Area 22 & 23, St Leonards South
26-50 Park Rd, 27-47 Berry Road, 48-54 River Road

RESPONSE TO COUNCIL RFI

Council Comment (Building D)

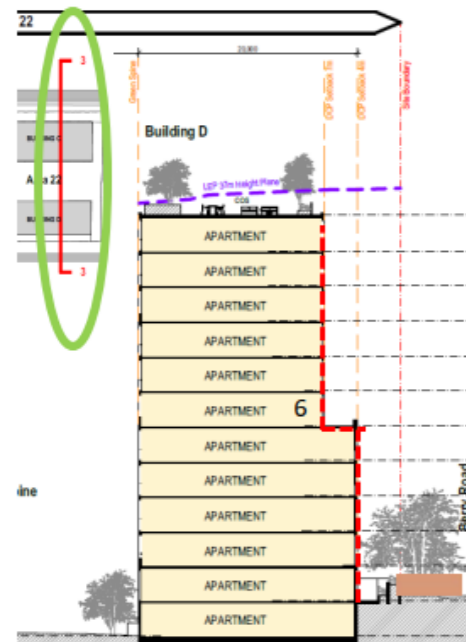
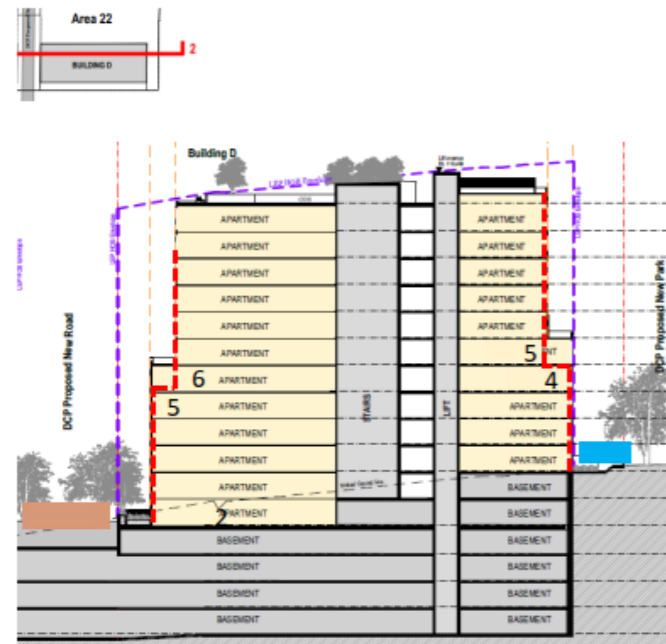
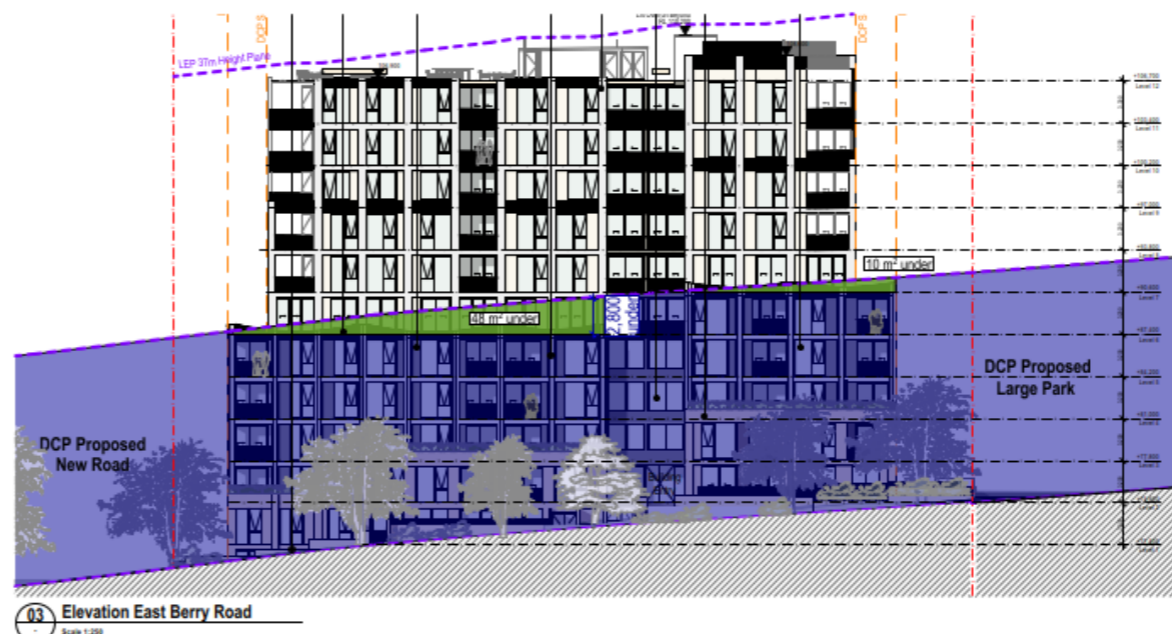
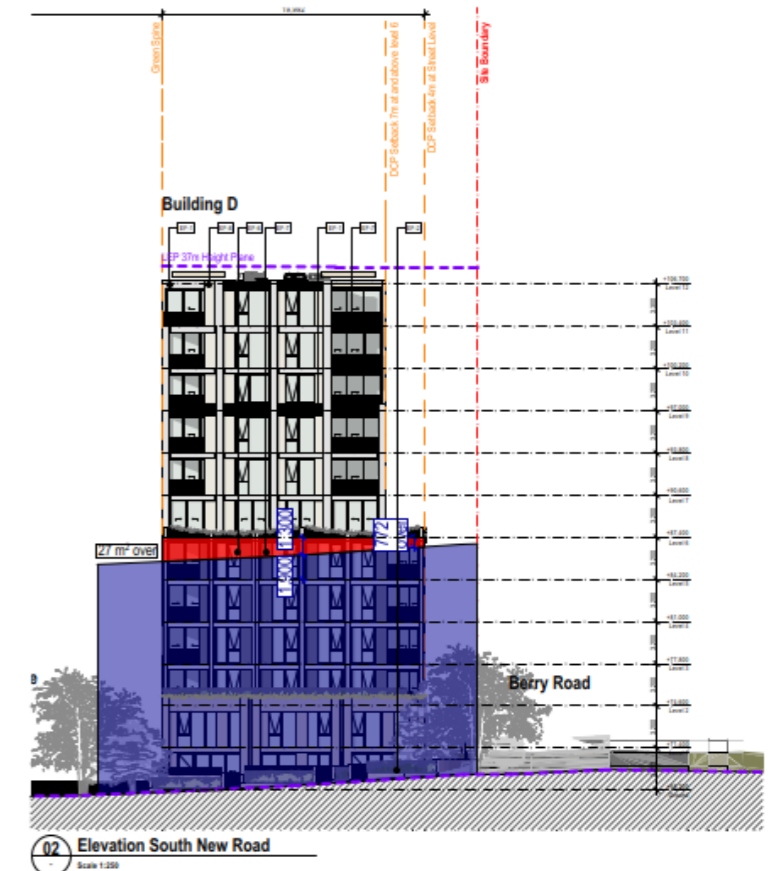
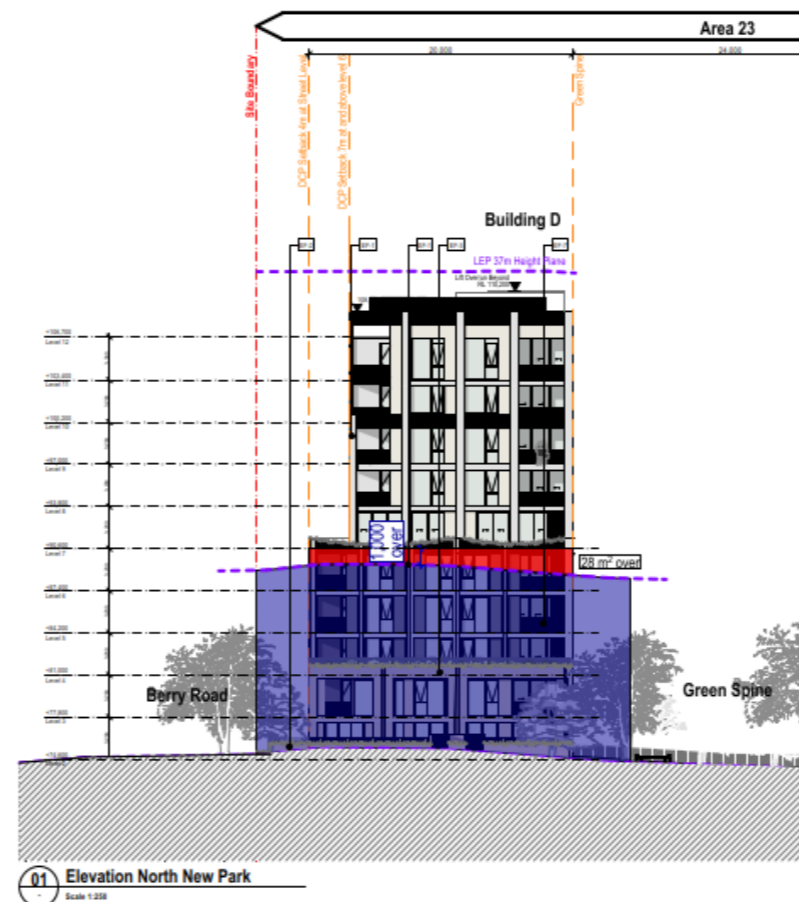
The proposed building setbacks do not comply with the DCP requirements at the following areas:

- DCP proposed New Road (Building D) 7m setback at level 6;
- DCP proposed New Park (Building D) 9m setback at level 5

The height in storeys has a minor non-compliance owing to the sloping nature of the site and the need to provide rationale floor plates. As a consequence elements of the street wall height marginally exceed the storey count and in some instances they fall below the DCP level. So the variation is justified on the grounds of the design responding to the sloping topography and adopting an average weighted approach, on balance, the proposal meets the intent of the control and thus represents an appropriate response.

Furthermore, Council has accepted an average weighted approach when supporting the front setback variations on the Area 7-11 project.

AVERAGING OF AREAS	
01 North Elevation New Park -	28 over
02 South Elevation DCP New Road -	27 over
03 East Elevation Berry Road	58 under
TOTAL	3 under

Council Comment (Building B)

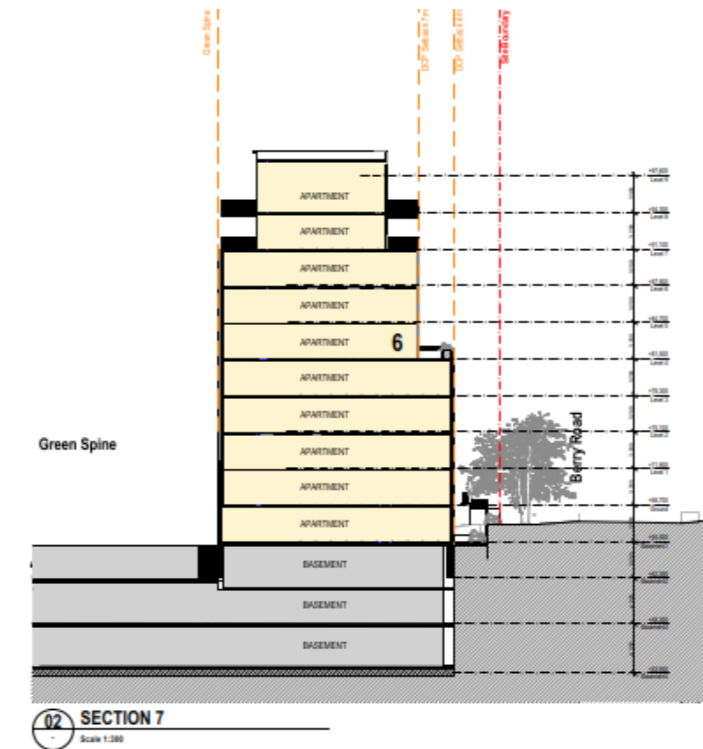
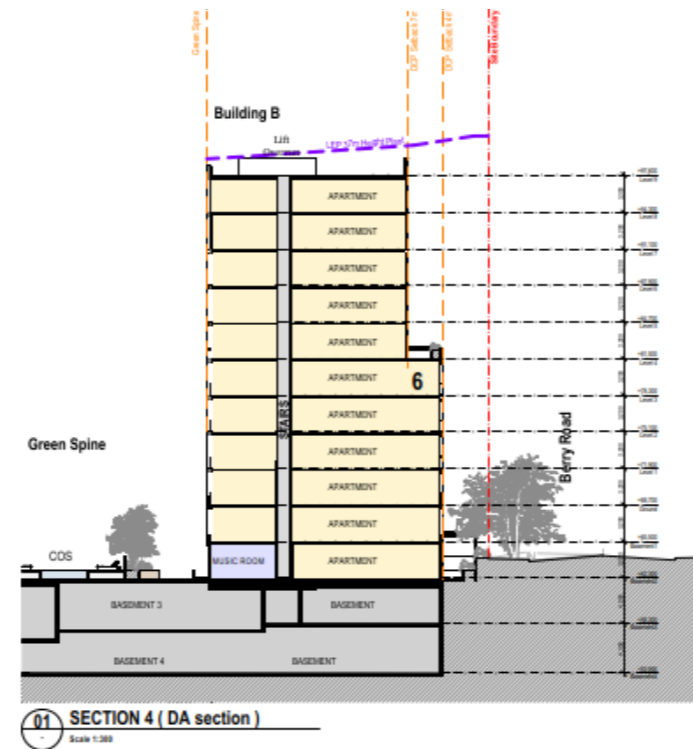
The proposed building setbacks do not comply with the DCP requirements at the following areas:

- Berry Road (Building B) 7m setback at level 6;

The height in storeys has a minor non-compliance owing to the sloping nature of the site and the need to provide rationale floor plates. As a consequence elements of the street wall height marginally exceed the storey count and in some instances they fall below the DCP level. So the variation is justified on the grounds of the design responding to the sloping topography and adopting an average weighted approach, on balance, the proposal meets the intent of the control and thus represents an appropriate response.

Furthermore, Council has accepted an average-weighted approach when supporting the front setback variations on the Area 7-11 project.

Council Comment (Building A)

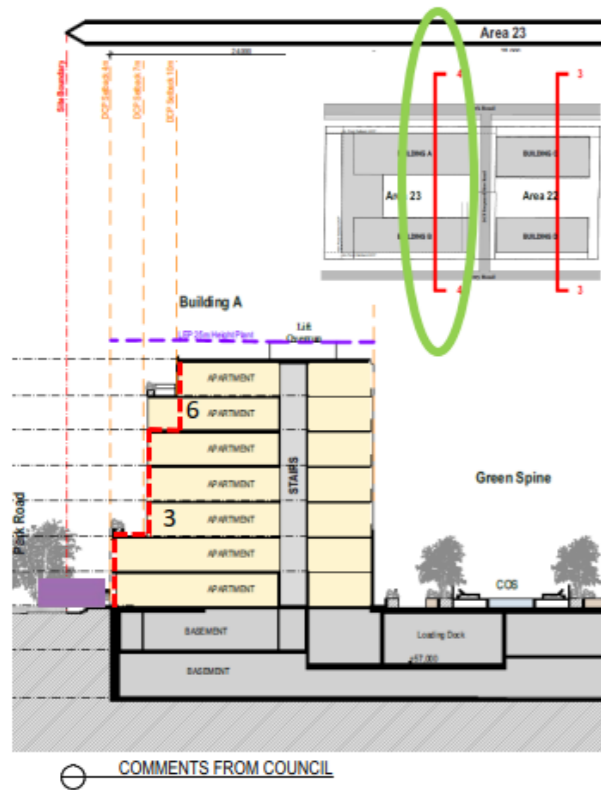
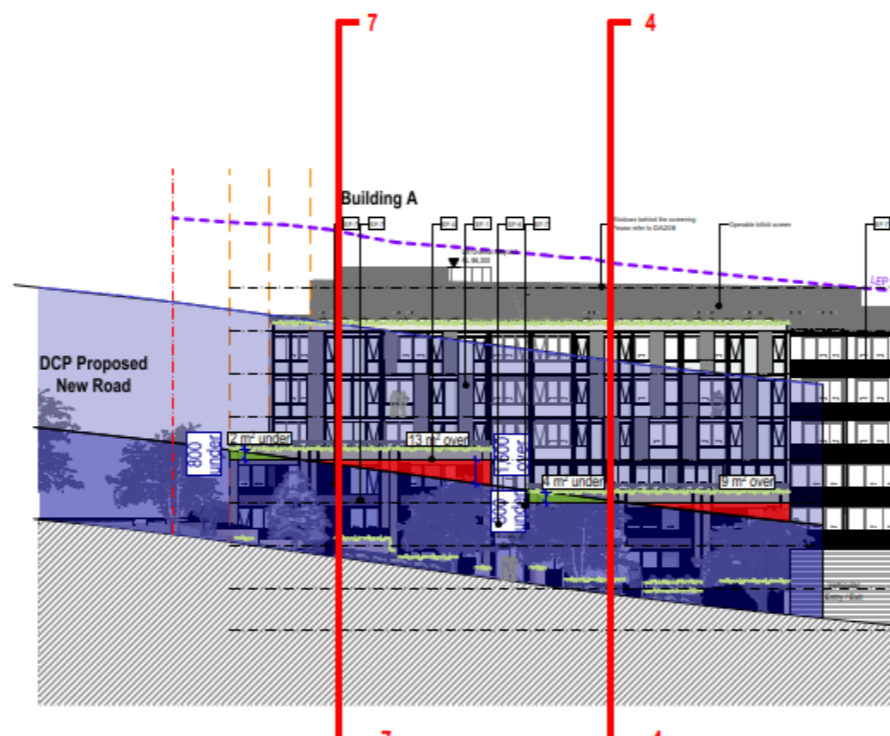
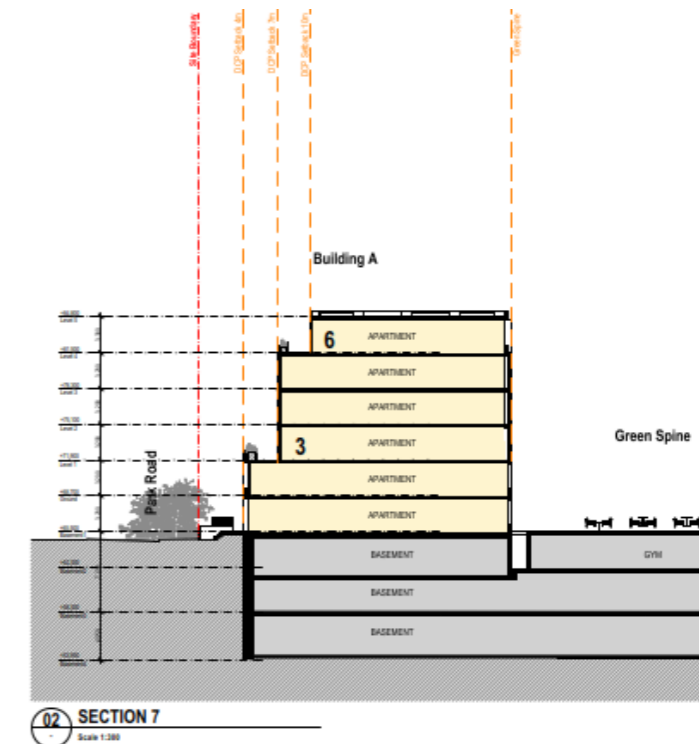
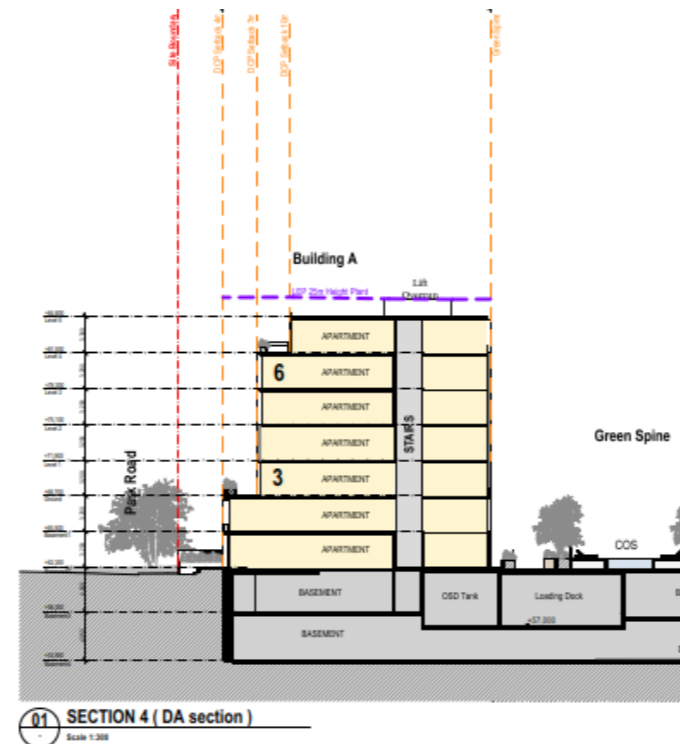
The proposed building setbacks do not comply with the DCP requirements at the following areas:

- Park Road (Building A) 10m setback at level 6;

The height in storeys has a minor non-compliance owing to the sloping nature of the site and the need to provide rationale floor plates. As a consequence elements of the street wall height marginally exceed the storey count and in some instances they fall below the DCP level. So the variation is justified on the grounds of the design responding to the sloping topography and adopting an average weighted approach, on balance, the proposal meets the intent of the control and thus represents an appropriate response.

Furthermore, Council has accepted an average-weighted approach when supporting the front setback variations on the Area 7-11 project.

Council Comment
(Building A & B)

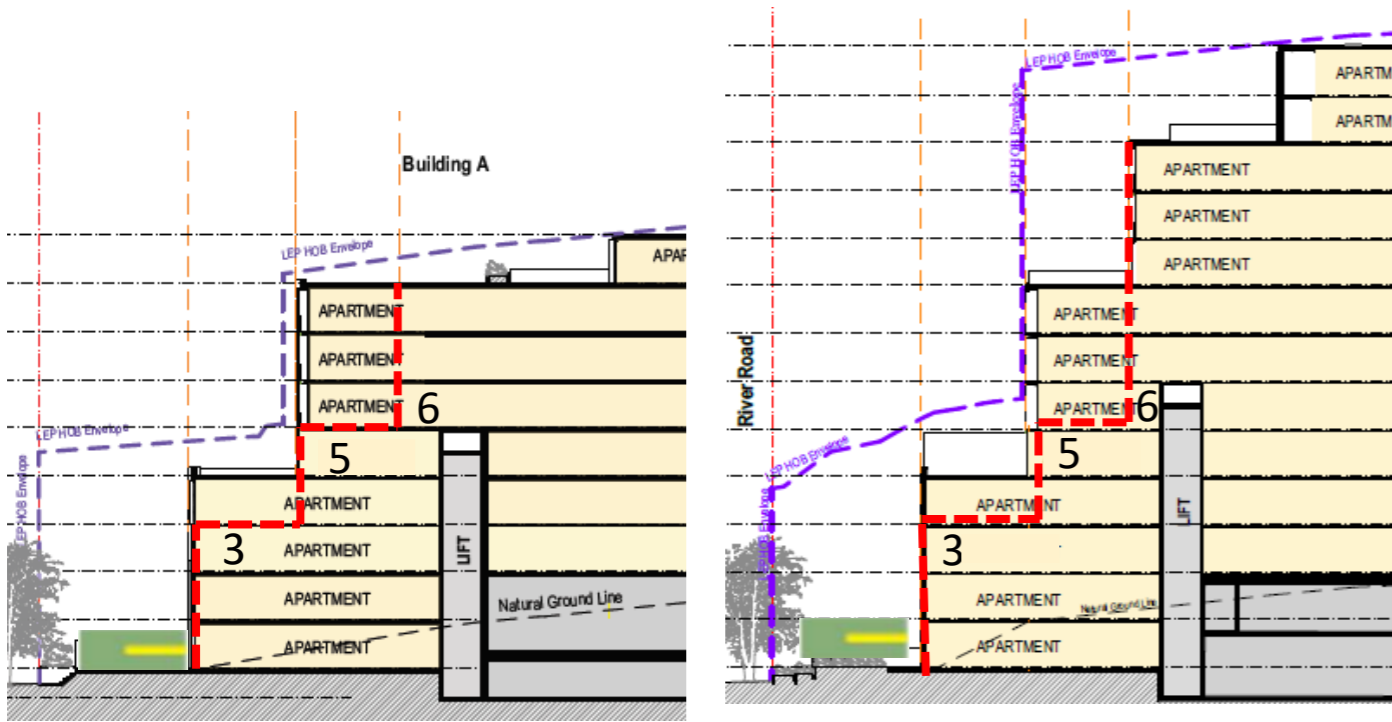
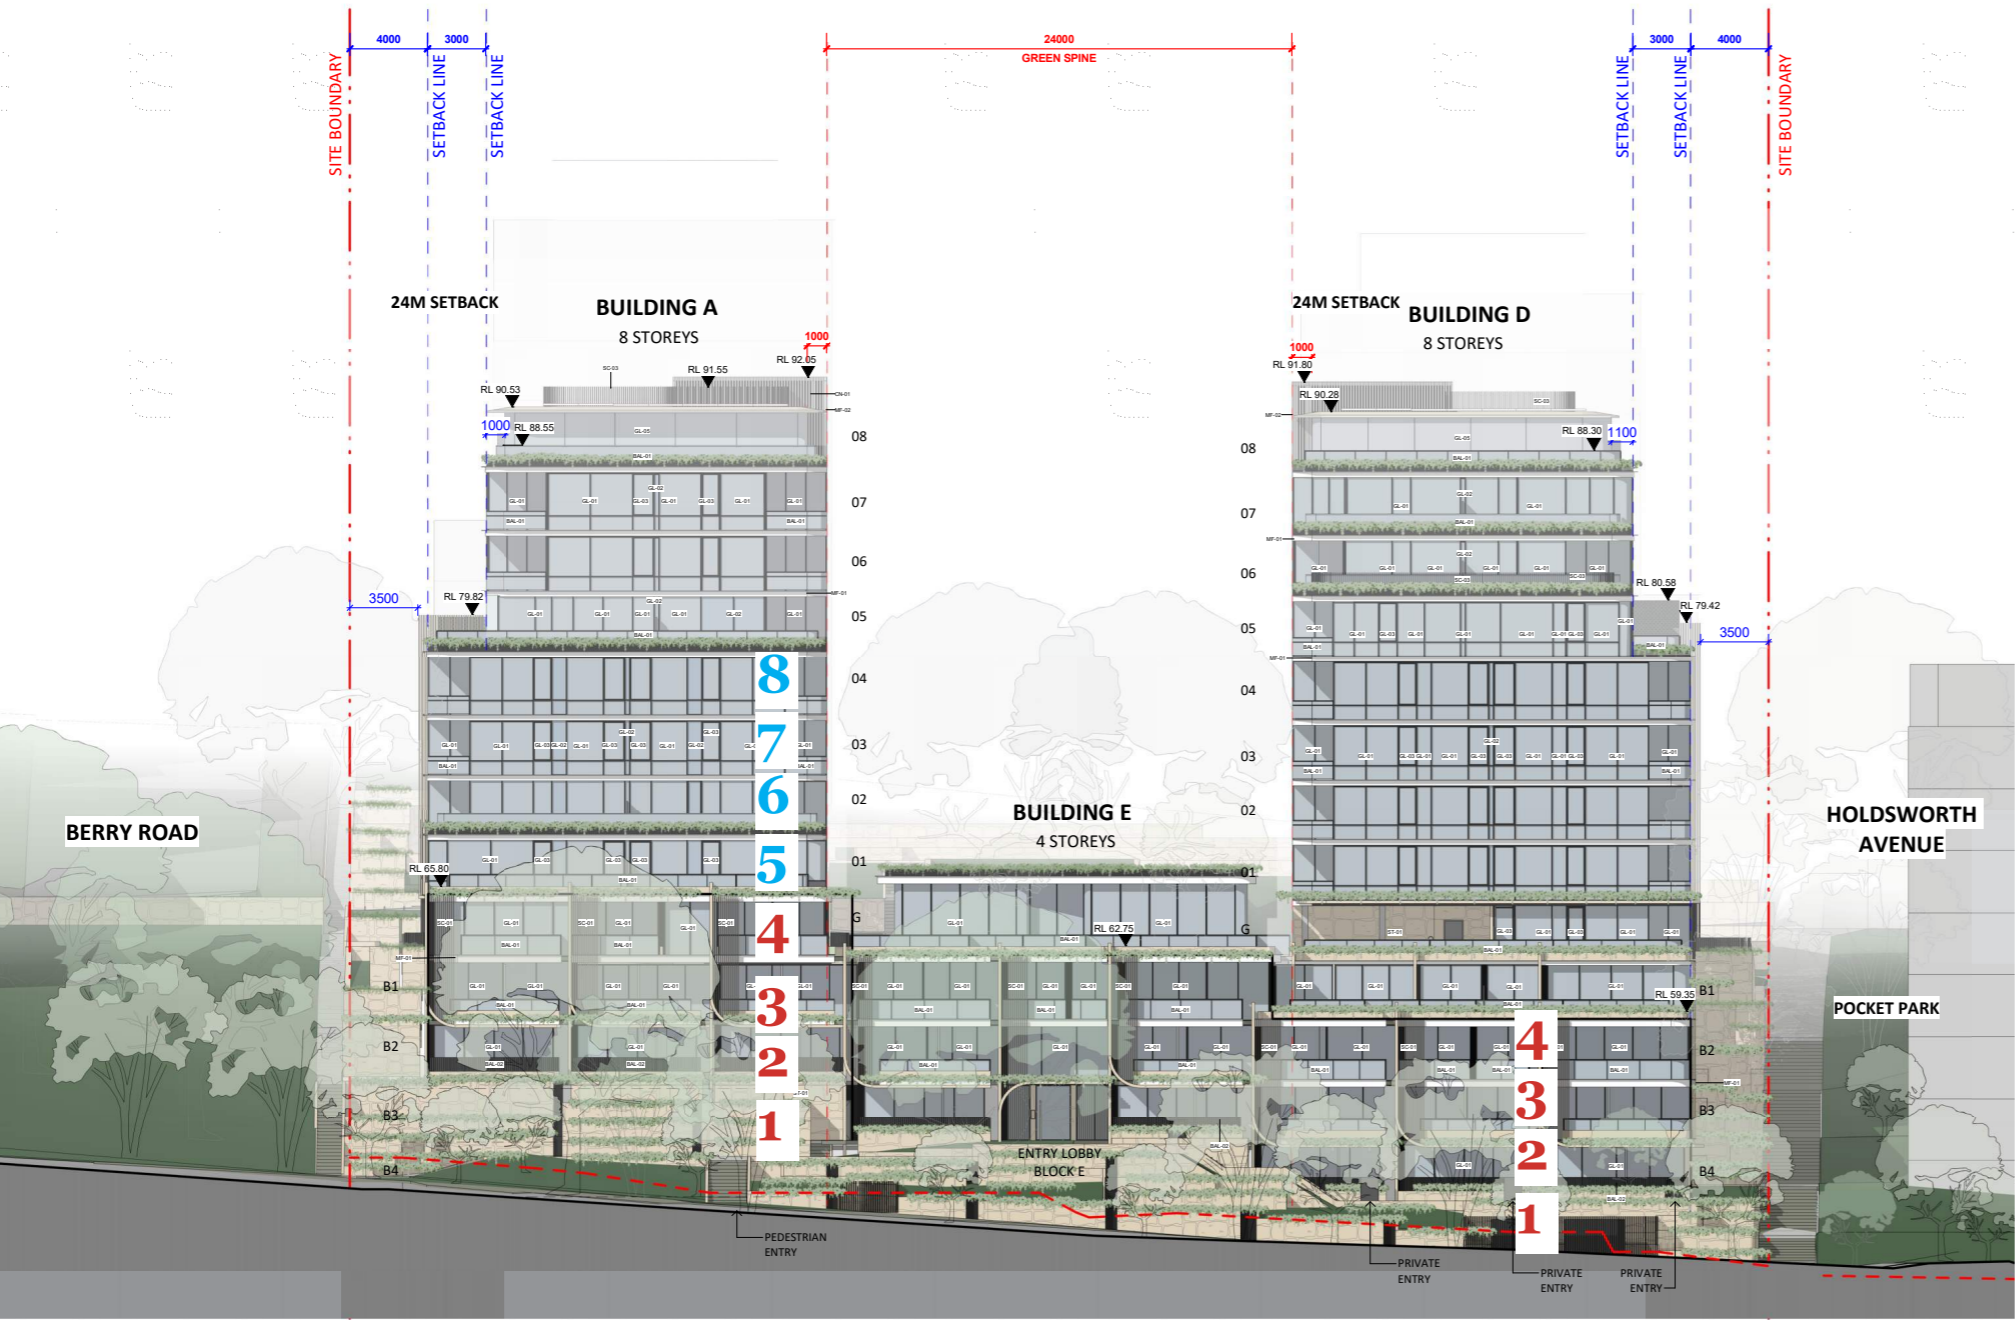
The proposed building setbacks do not comply with the DCP requirements at the following areas:

- River Road frontage (Buildings A and B) 17m setback at level 4 and 24m setback levels 6 and above;

- River Road frontage (Buildings A and B) 17m setback at level 4 and 24m setback levels 6 and above;
